# SERVICE BULLETIN

**NO. ARC-SB-852-010**

**Revision: B**

Installation of a spacer in each of the Main Landing Gear Retraction Actuators.

**Figure 1, Spacer installed against piston and end cap. Spacer step away from piston.**

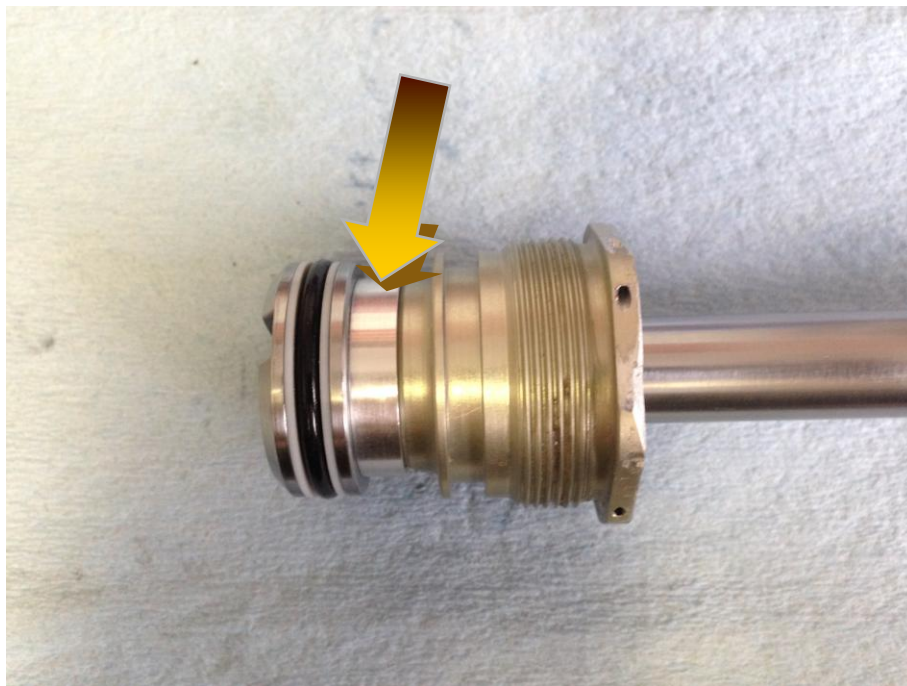
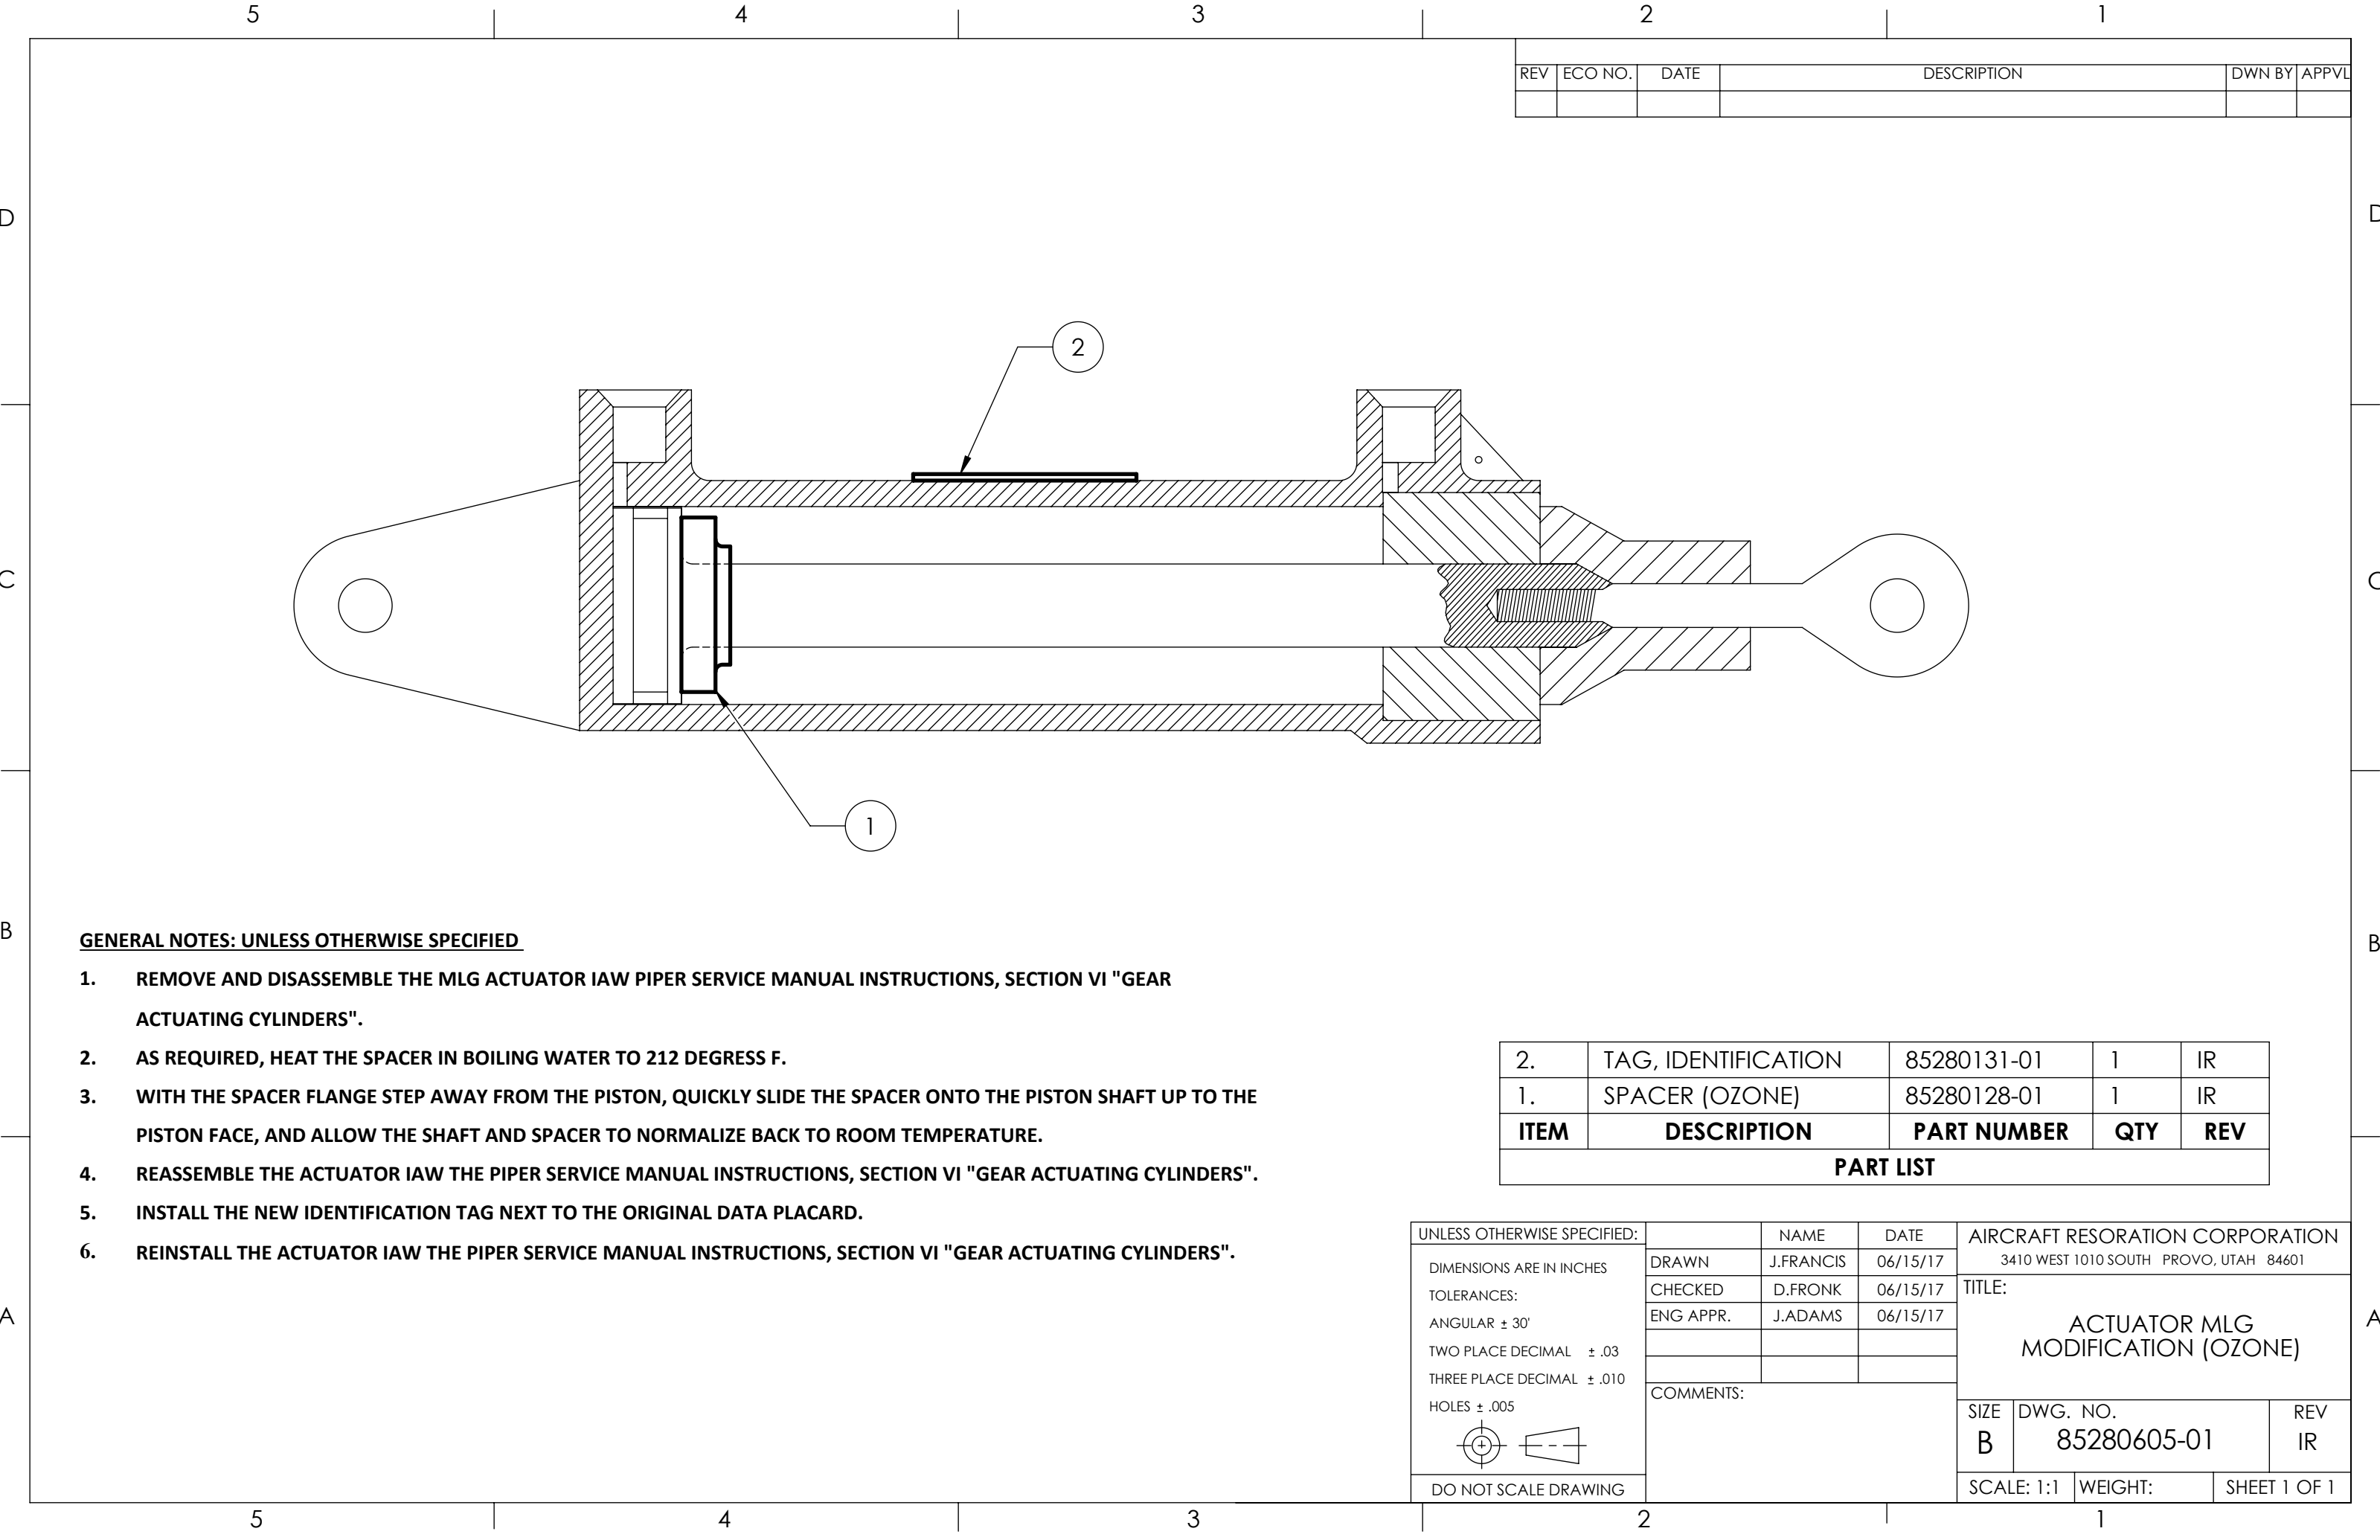
Remove end caps, install the new spacer (P/N: 85280128-01 for Ozone or 85280128-02 for Wiebel) on the ram shafts in accordance with drawings 85280605-01, Actuator MLG Modification (Ozone), and 85280605-02, Actuator MLG Modification (Wiebel) (copy attached). Reassemble actuators and reinstall them in their original locations. Rig the MLG in accordance with the Piper Service Manual Instructions, Section VII, "Landing Gear and Brake System".

**Note:** On Wiebel actuators, ensure the spacer small diameter extension step fits inside of the End Cap Gland Nut cavity. On some early model end caps, Wiebel vendors did not machine the cavity in their final manufacturing process. The end cap cavity should measure .75 diameter and .40 deep minimum to accept the spacer step as shown in Drawing 85280605-02.
